Department of Planning and Environment
North Byron Parklands wastewater management
Review of additional information

September 2018

The Department of Planning and Environment (DPE) engaged GHD to review the waste water management plans of North Byron Parkland's development application for expansion and addition of the annual festival activities at the Site. GHD identified discrepancies and shortcomings in the proposal as detailed in GHD's report of August 2018.

Figure 2 Proposed wastewater management

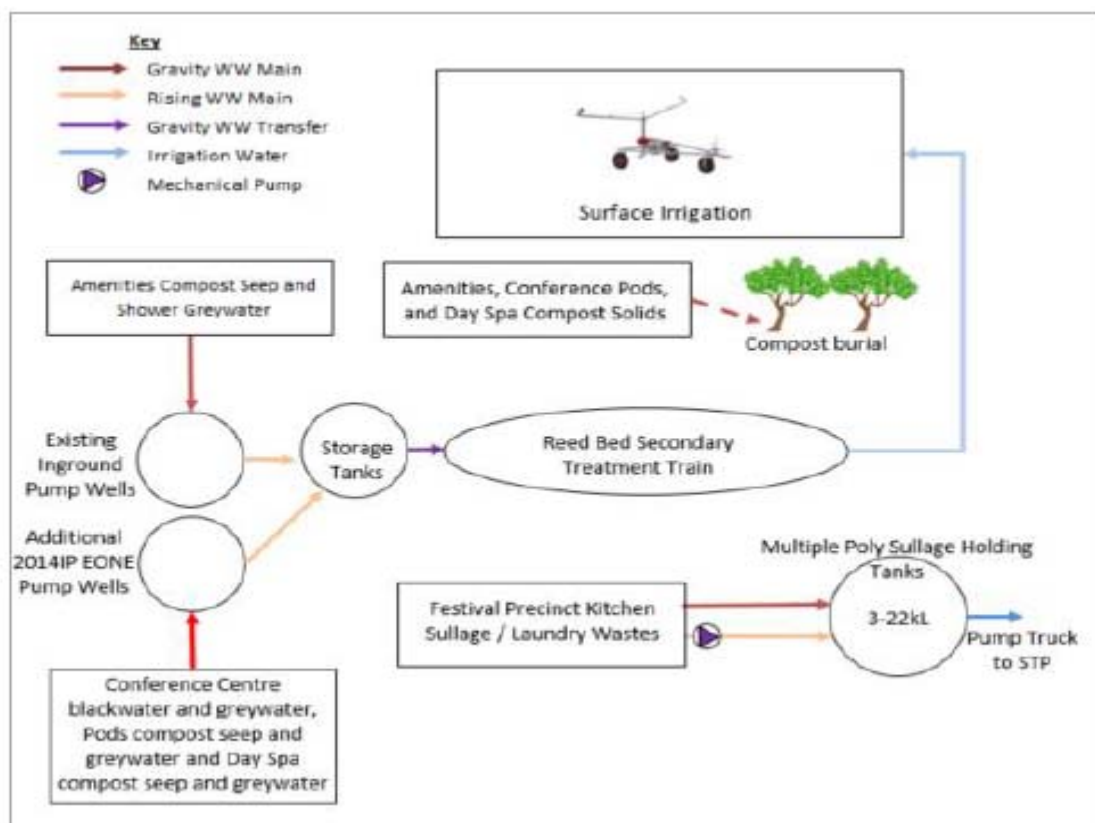
GHD still consider the numbers used for wastewater production rates seem low, and they are certainly very low compared to published figures, although it is noted that event values have been used and it is also acknowledged that the installed water use reduction measures (timed showers, dry compost toilets, etc.) will contribute to lower volumes generated.

The greatest discrepancy is considered to be the allowances for the conference and spa centre, which based on expected occupancy rate and general allowances would be around 40 – 60 % more than what W&A have nominated. Again, it is acknowledged that there will be wastewater reduction from standard allowances with installation of composting toilets and water saving devices, but if people are staying in accommodation, they do not tend to minimise usage of water. It is also noted that the characteristics adopted (Table 11 in Appendix E submission) are more concentrated than sewage (despite contradiction in the page above that there will be “low strength influent of similar to weaker strength effluent compared to a domestic system”).

As can be seen comparing the W&A stated contaminant reduction (column 4) vs industry accepted reduction values (column 5), unrealistic treatment efficiencies have been adopted for the proposed effluent treatment system. GHD is not convinced that the stated relatively low concentrations of contaminants in treated effluent (column 3) will be achieved.

The reed bed loading at 112 kg BOD/ha.d is probably a little high, but it is considered that the BOD load will be approximately double what has been allowed for (which means that the BOD loading on the reed beds will be significantly above accepted criteria). Most reed bed systems are designed for smaller equivalent population than this proposed system and do not treat

Consequently, it is considered that a low nutrient level i.e. treated water quality suitable for irrigation re-use, will not be achieved by the proposed treatment system. GHD's estimate is that N and P levels likely will be closer to 150 – 200 mg/L and 30 – 35 mg/L respectively in the irrigated effluent.

In addition, GHD considers that a reed bed system is not capable of achieving SS concentration in the effluent < 5 – 10 mg/L. The proposed use of chlorine may also be problematic and it is considered there is an error in the estimated dosage of disinfectant. Suggested chlorine dosage is 0.48 kg tablets per day, stating that the product is of 65 % chlorine concentration. However, tablets are typically granular calcium hypochlorite and based on molecular weight available chlorine is about 49 %, which means that some 1 kg of tablets will be required daily to treat 35 kL/day. However, GHD consider that the state of effluent is likely to require significantly more than this. A risk arising from relying on high chlorine levels to achieve the desired outcome is that chlorinated organics constitute environmental issues and risks.
